ENGINE - HP TURBINE ROTOR AND STATOR ASSEMBLY - PROVIDE NEW STAGE 2 HPT VANES WHICH
HAVE INCREASED COOLING AIRFLOW - CATEGORY CODE 8 - MOD.ENG-72-0266

V2500-ENG-72-0266

SERVICE BULLETIN

Location of the Stage 2 High Pressure Turbine (HPT) Vane Assemblies
Fig.1

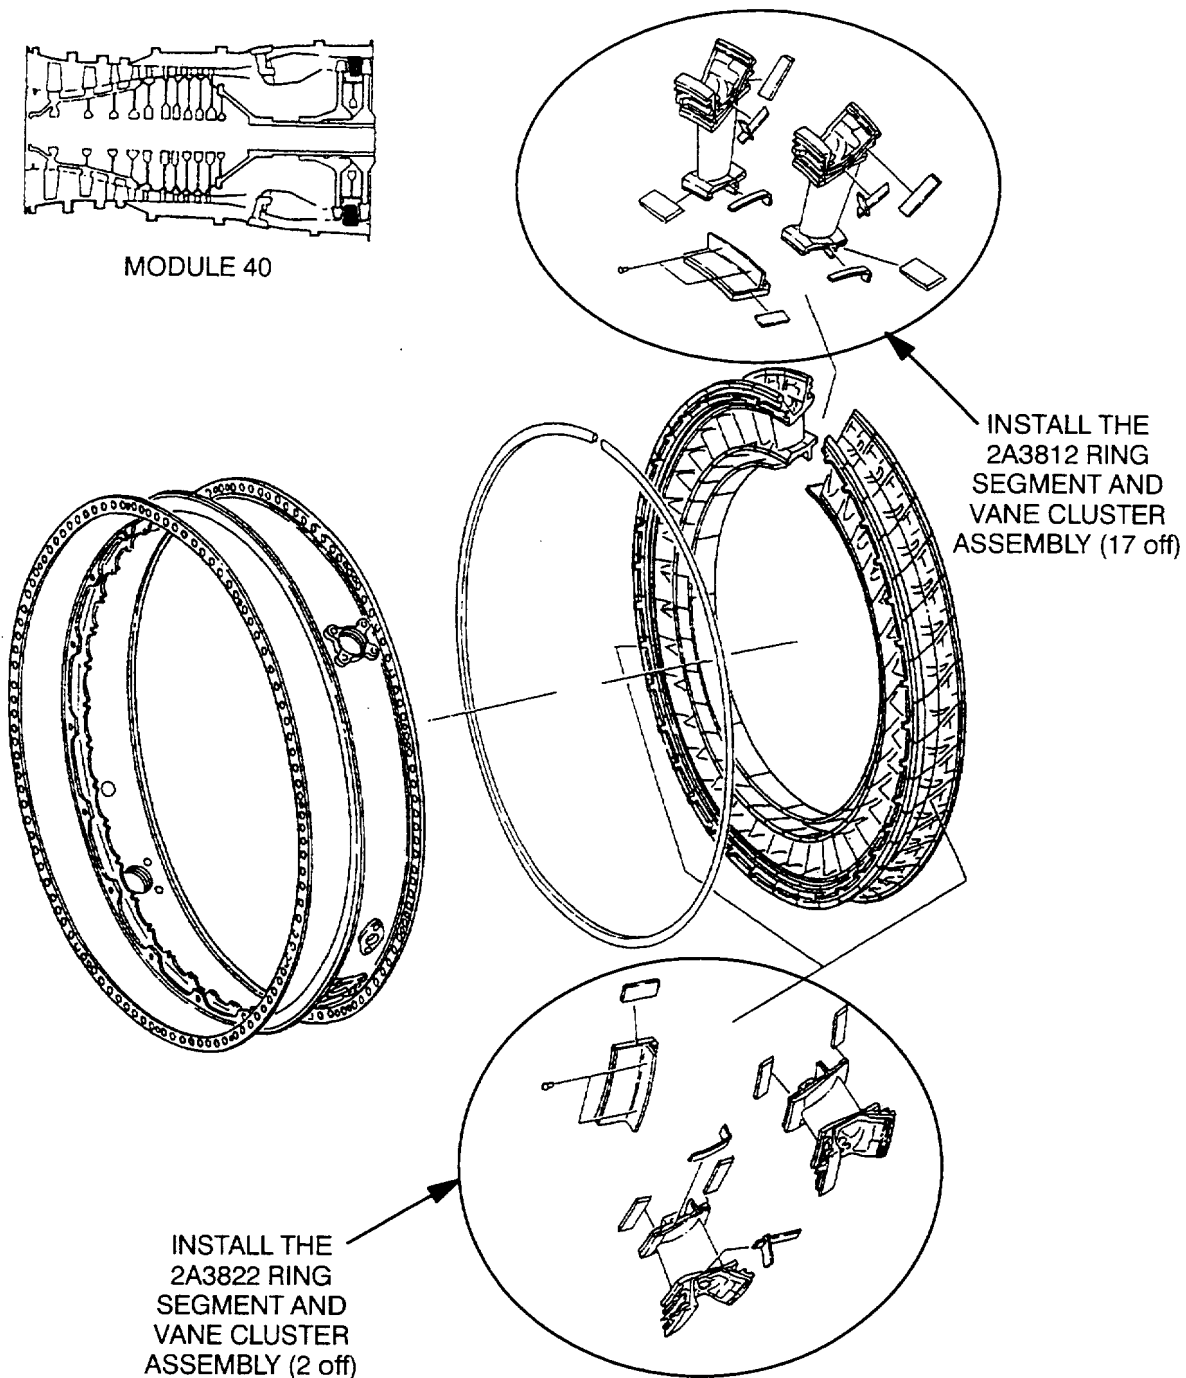
(1) Install new Stage 2 HPT Vane Assemblies.

- A. Replace the 2A3832 Stage 2 HPT Vane Assembly (2 off) with the 2A3402 Stage 2 HPT Vane Assembly when you assemble the new Stage 2 HPT Ring Segment and Vane Cluster Assembly by the procedure specified in Reference (2), Chapter/Section 72-45-24 Repair 18 (VRS 3391).

- B. Replace the 2A3842 Stage 2 HPT Vane Assembly (1 off) with the 2A3302 Stage 2 HPT Vane Assembly or replace the 2A3832 Stage 2 HPT Vane Assembly (1 off) with the 2A3402 Stage 2 HPT Vane Assembly when you assemble the new Stage 2 HPT Ring Segment and Vane Cluster Assembly by the procedure specified in Reference (2), Chapter/Section 72-45-24 Repair 18 (VRS 3391).

Family Tree - Stage 2 High Pressure Turbine Vane Assembly Ref. Catalog Sequence No.
72-45-24. Fig. 02 Items 130 and 350
Fig.2

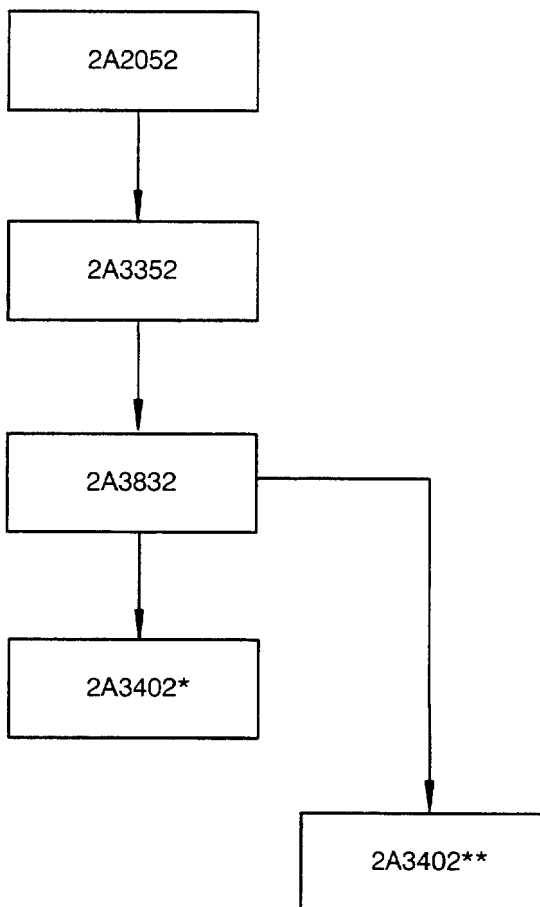
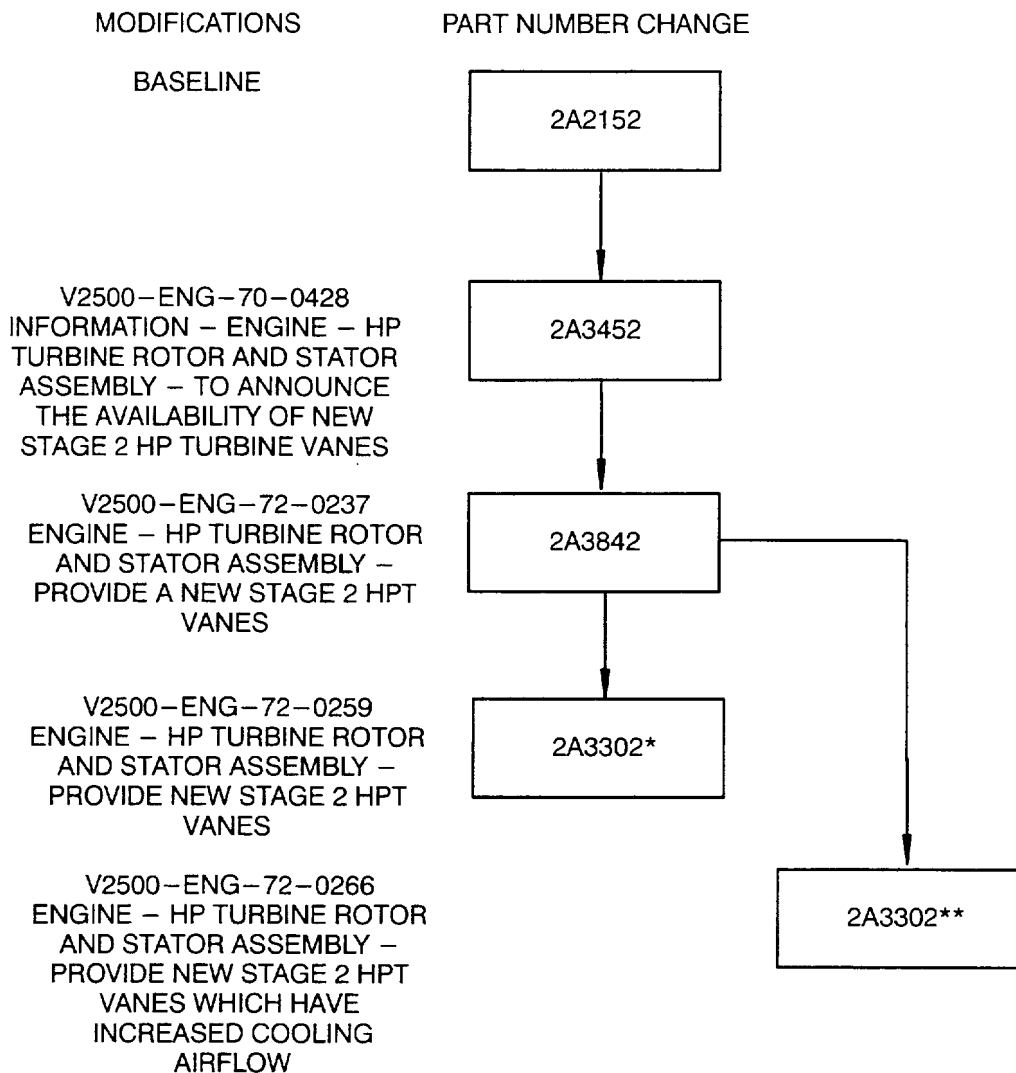
V2500-ENG-72-0266
ENGINE - HP TURBINE ROTOR
AND STATOR ASSEMBLY -
PROVIDE NEW STAGE 2 HPT
VANES WHICH HAVE
INCREASED COOLING
AIRFLOW

PART NUMBER CHANGE
